## LiDAR Quality Assessment Report

UT\_HurricaneFault\_2011

This data set created using LiDAR points collected from airborne surveys completed on October 26, 2011 and covers approximately 36 square miles contained in the following county(s): Iron County, Utah; Washington County, Utah; Mohave County, Arizona.

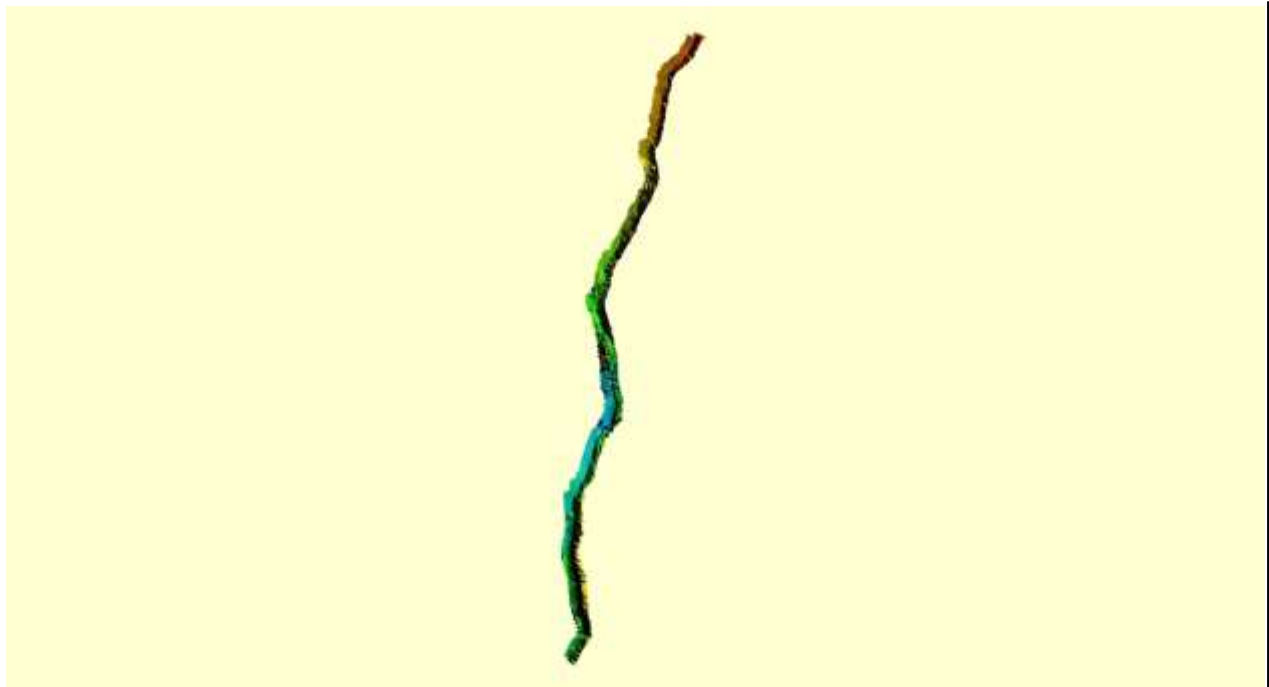
Mosaic of original DEM tiles above, some edge issues due to mismatch between the DEM and project extent.

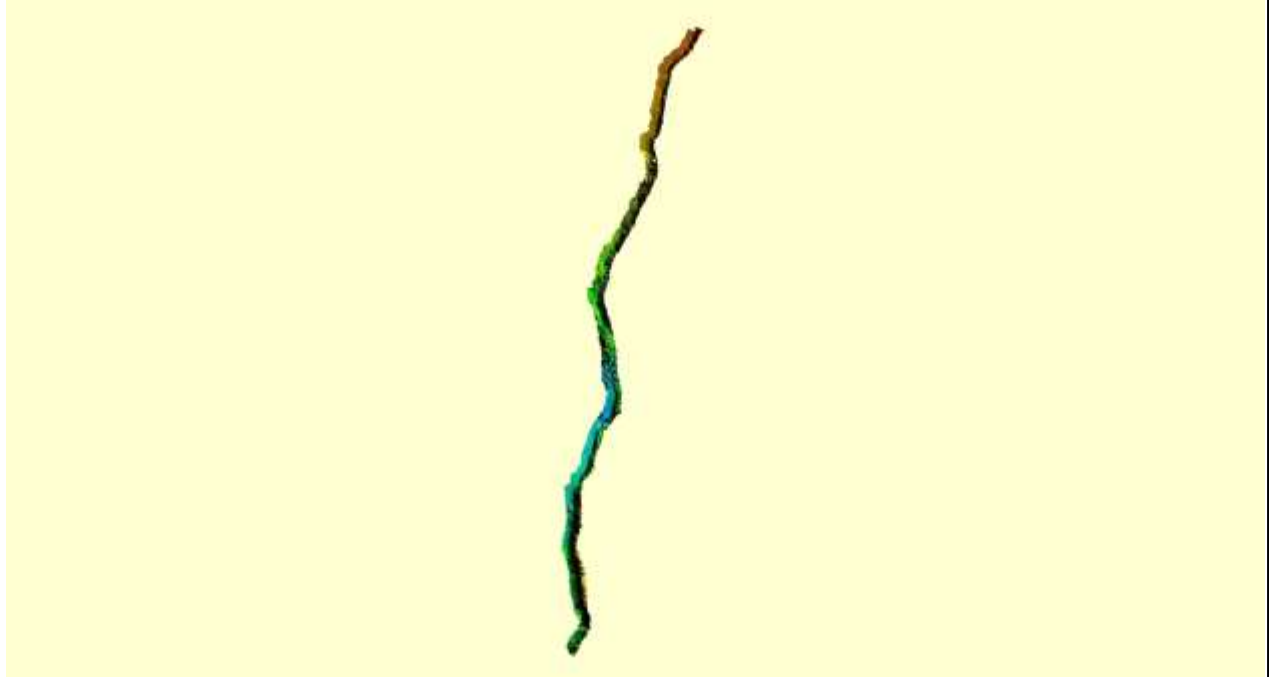
In order to make the DEM usable in the 1/9th NED the edge issues were corrected and the project was buffered in by 100 M. This also has an accompanying DEM Project Footprint and has an area of 30.33 SqMi.

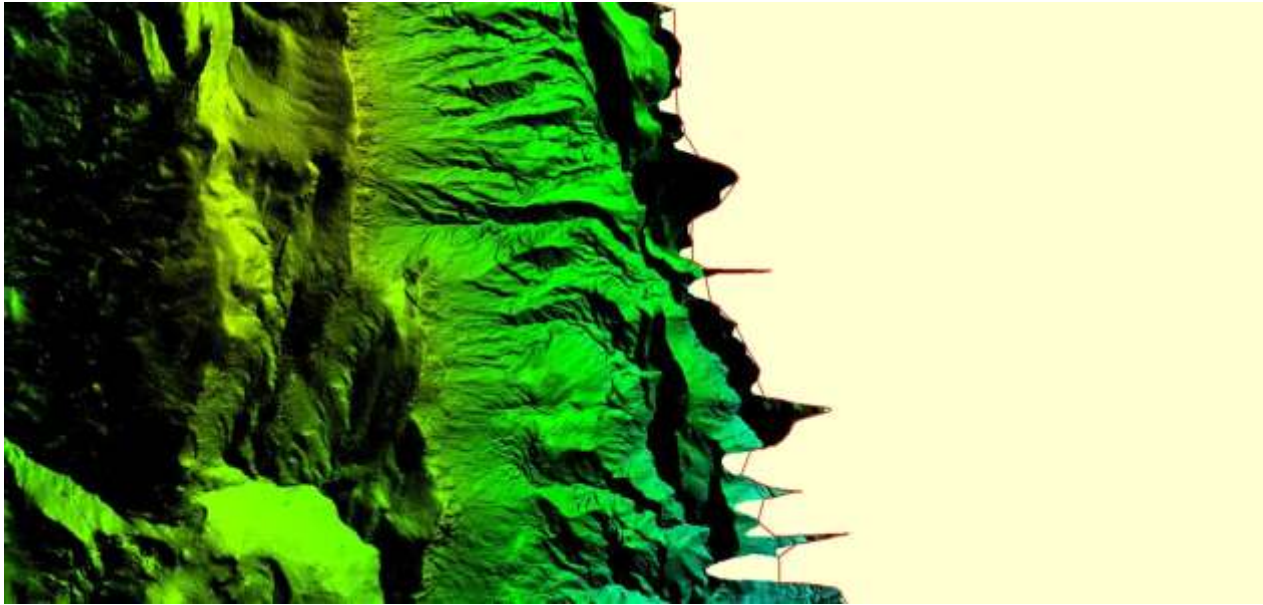
The Project extent and gridded data did not match, in order to reduce edge artifacts and data voids the final DEM was buffered in by 100 Meters.

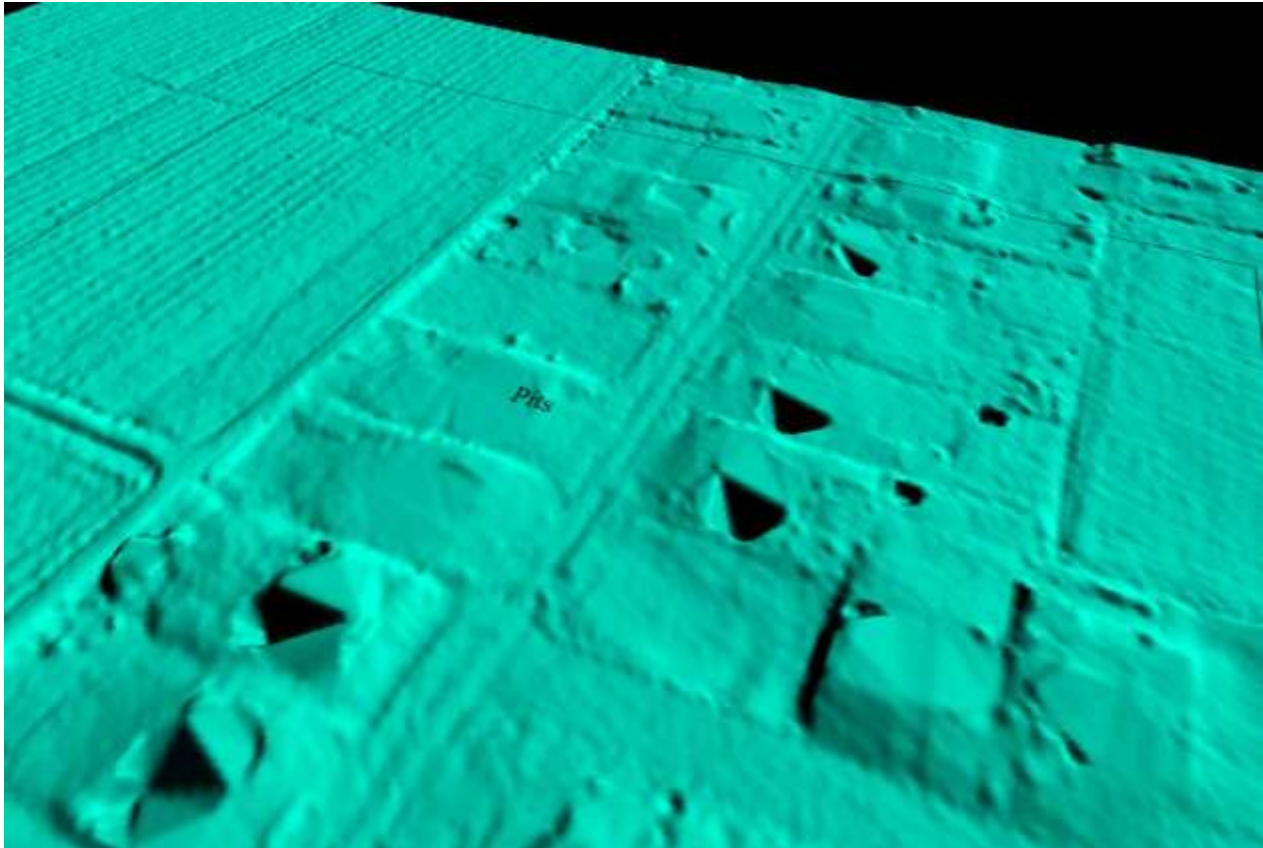
There were a few instances of pits/sinks in areas where structure removal had been performed. 3d view above. These Pits were filled in the final DEM mosaic sent to the NED.

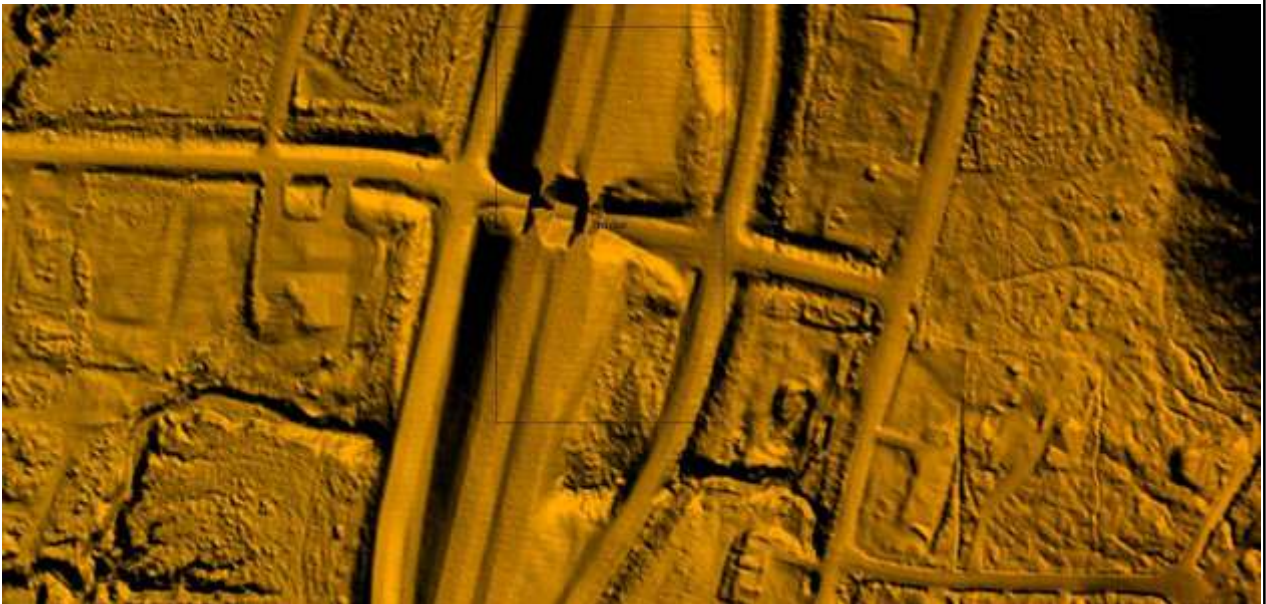
Pits/sinks from overhead perspective.

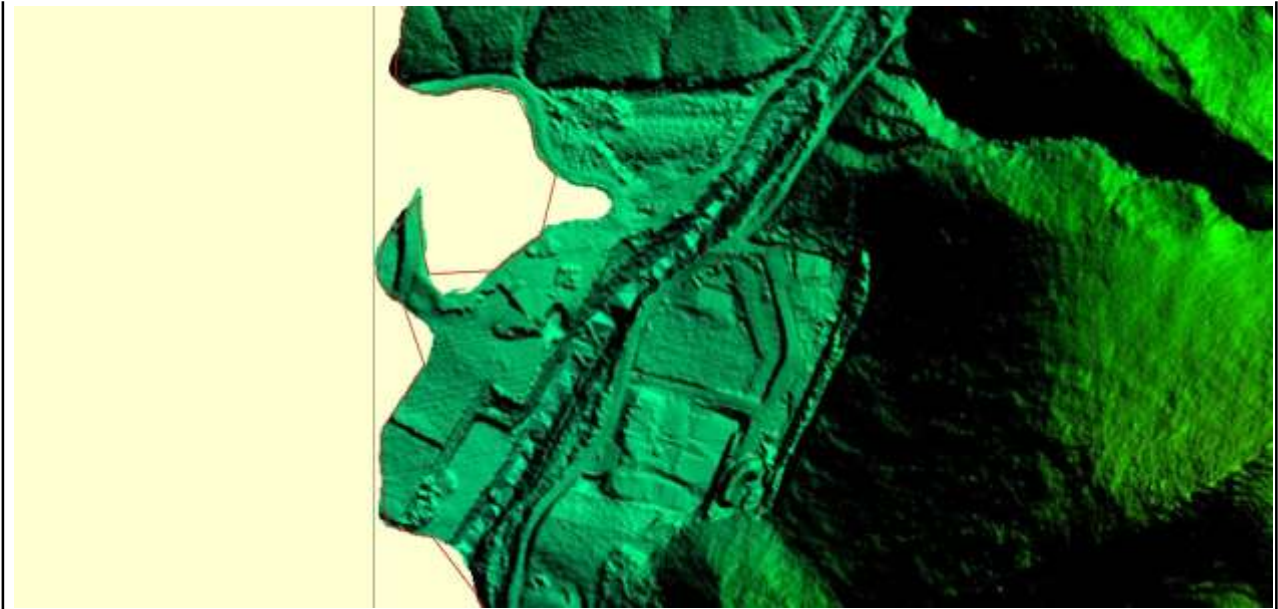
A few instances of bridge Removal issues. These Bridges were leveled in the final mosaic DEM sent to the NED.
